**City of Bellevue  
Development Services Department  
Land Use Staff Report**

**Proposal Name:** Ridgeway Shoreline Buffer Modification

**Proposal Address:** 67 Cascade Key

**File Number:** 09-130269-LO

SHEET NUMBER  
**L1.1** SET  
CRITICAL AREAS  
PERMIT SUBMITTAL

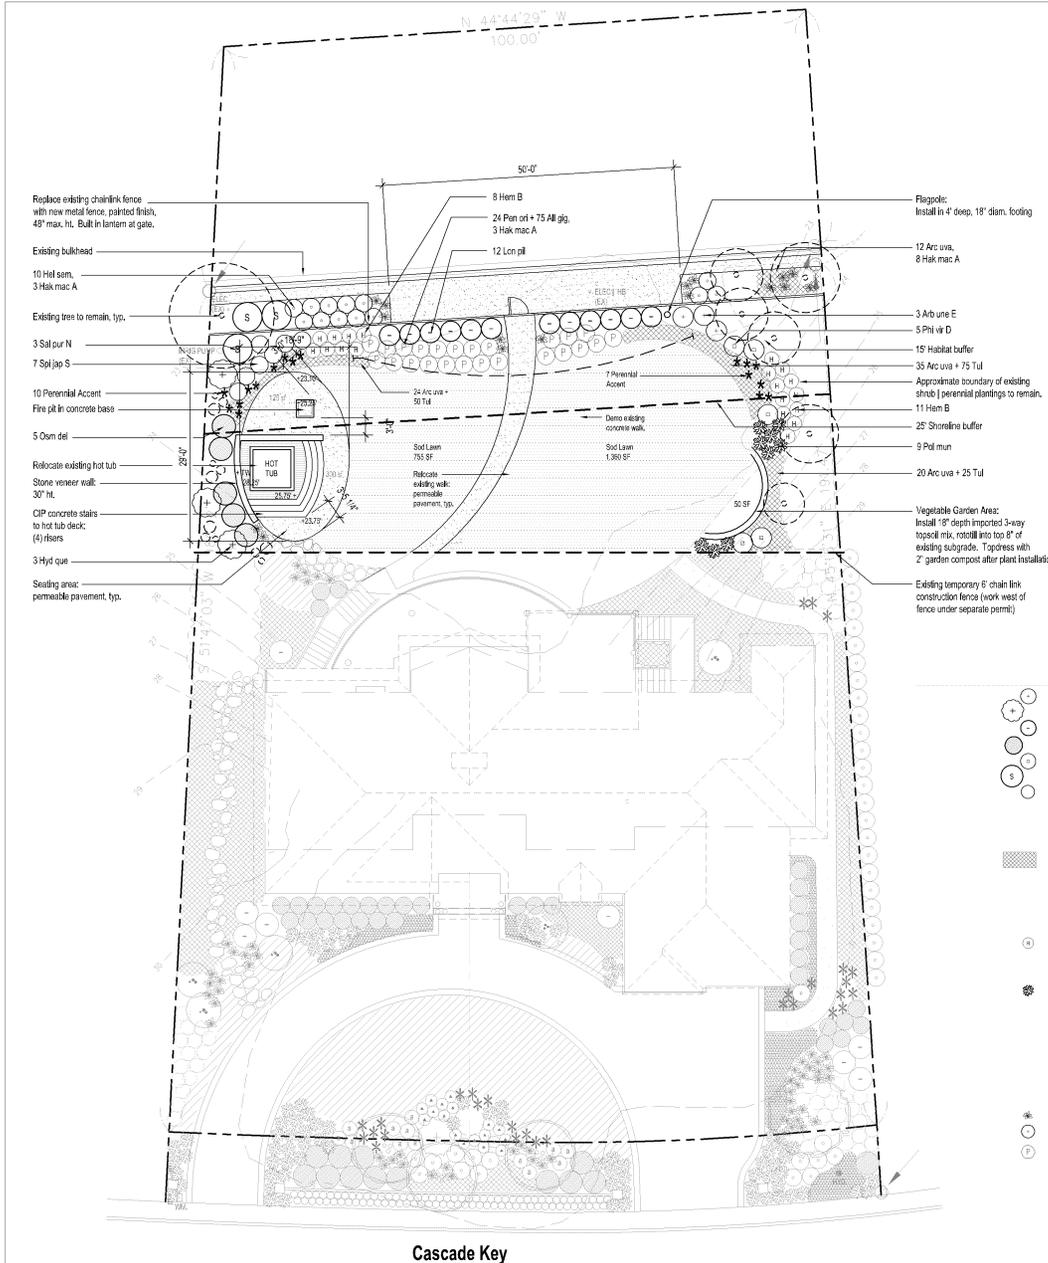
Erosion control already exists on the site as a result of previous permit approvals. Existing trees are being retained and 950 square feet of landscaping and soil amendment is being provided per the submitted landscaping plan as Attachment 1. The plants within the first 15 feet from the shoreline are defined on the plans as a habitat buffer as this area has the only opportunity on the site to input into the water. As a result, this 15-foot planting area needs to be planted with native plants. See Conditions of Approval in Section IX of this report.

The Notice of Application for this project was published the City of Bellevue weekly permit bulletin on December 10, 2009. It was mailed to property owners within 500 feet of the project site. Comments were received from Karen Walter with the Muckleshoot Indian Tribe regarding the proposed planting plan and the use of non-native plants as depicted on the plan. A condition of approval will require the use of native plants within the first 15 feet landward of the shoreline which is called the "habitat buffer" on the planting plan. See Conditions of Approval in Section IX of this report.

- 2. No Fence Replacement Allowed:** Per LUC 20.25E.080.Q no fence is allowed to be placed within the shoreline buffer or structure setback which is essentially parallel to the shoreline. The existing fence on site can be maintained and repaired but the proposed new fence is not allowed. Fences which are perpendicular to the shoreline are allowed. The plans must show no new fence proposed either through redline or plan revision in order for a development permit to be issued.

- 3. Native Plants:** Native plants are required to be planted in the 15-foot habitat buffer along the shoreline. The mitigation planting plan must be revised to show only native plants and varieties before any development will be issued.
